As some of you may be aware, Berson is in the process of changing their existing Insectron ATEX certification (01ATEX2146X from 2001) towards the newest ATEX certification ATEX 2014/34/EU.

Change Bulletin: Insectron ATEX Approval

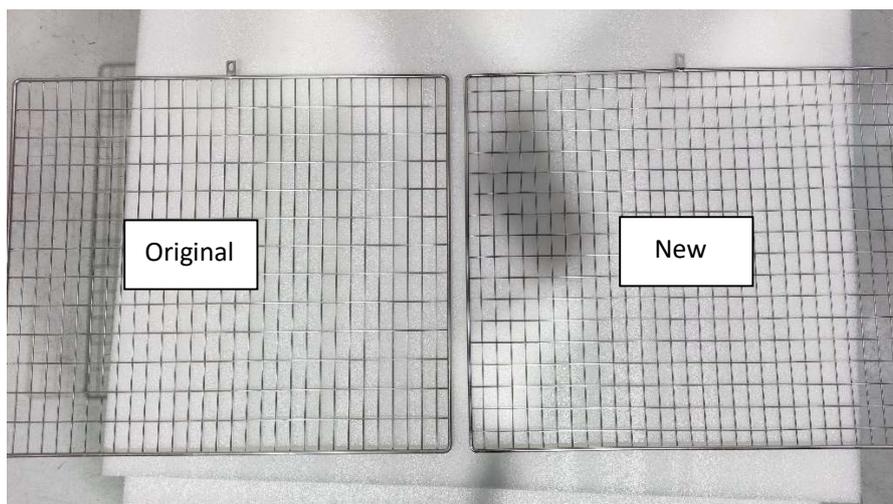
1. Safety grid design
   The grid size and material of construction of the safety grid has changed. The two pictures below show the differences in the original safety grid and the new safety grid.

The original grid was made of galvanized steel. The new grid is made of SST-304, which has a higher potential to resist corrosion.

New type Safety grid with smaller size holes made from SST-304 material

Comparison between original used and new type. Note the original type was made from galvanized steel

Flathead screw is replacing the knurled screw

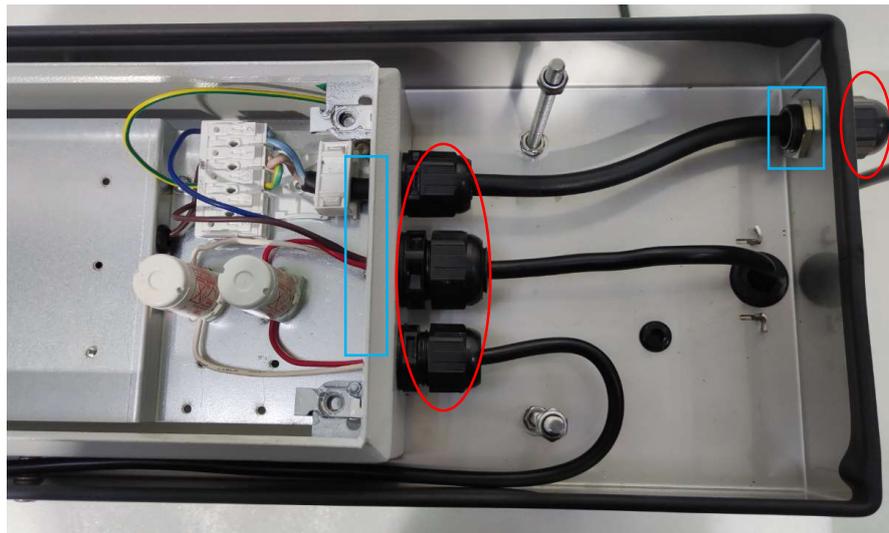
2. Knurled bolt – changed to the flat head screw.

To knurled screw used to hold the safety grid in place has been changed to a flathead screw. Where previously no tool was required to remove the safety grid, a flathead screwdriver is now required.

New used cable glands and their metal counter parts to follow newest ATEX regulations.

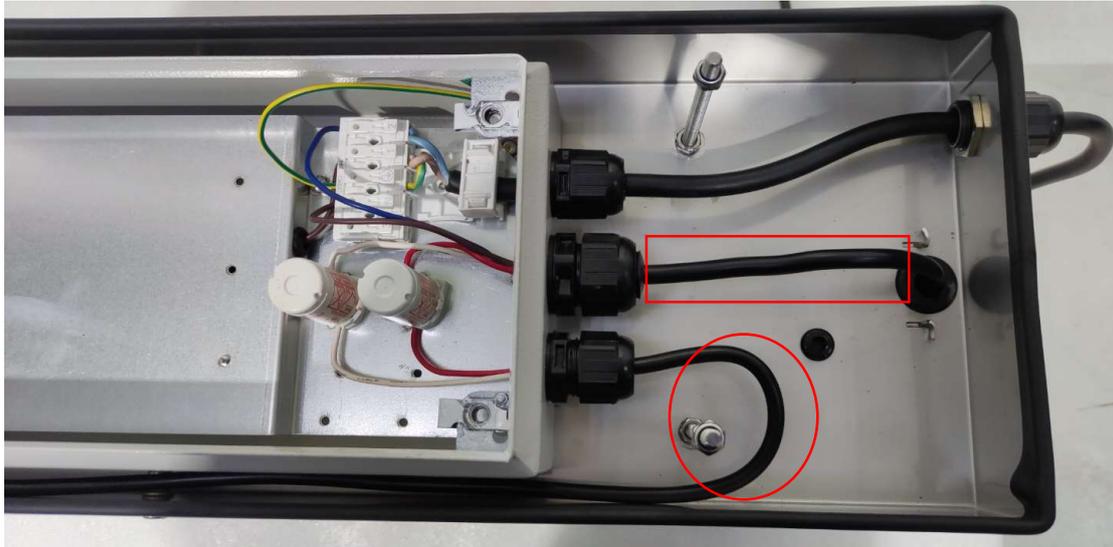
3. Glands and metal rings changed.

The cable glands have been upgraded from the current plastic design to a more robust material.

Picture showing the new used type Internal wiring cables

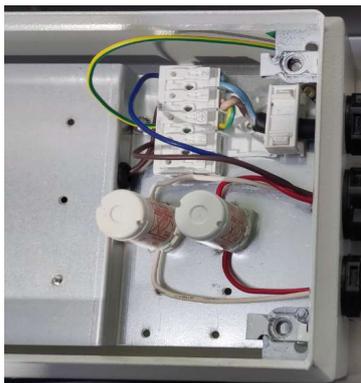
4. Internal cable trees

Internal cable routing has been changed.
